DART ENGINEERING ORDER

TO AMEND DRAWING D2650 REV. C

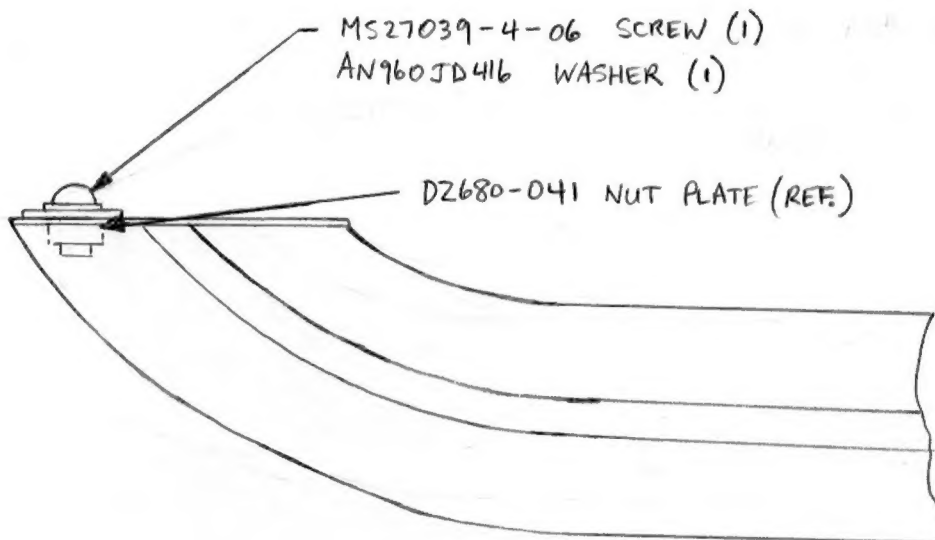
INSTALL MS27039-4-06 SCREW IN D2680-041 NUT PLATE
LOCATED ON FWD END OF D2650-1/-3/-5/-7 SKIDTUBE ASSEMBLIES.
SEAL WITH SIKAFLEX 241/291 SEALANT.

NOTE: AN4-3A BOLT CAN BE SUBSTITUTED FOR MS27039-4-06 SCREW
IF MS27039-4-06 ARE UNAVAILABLE.
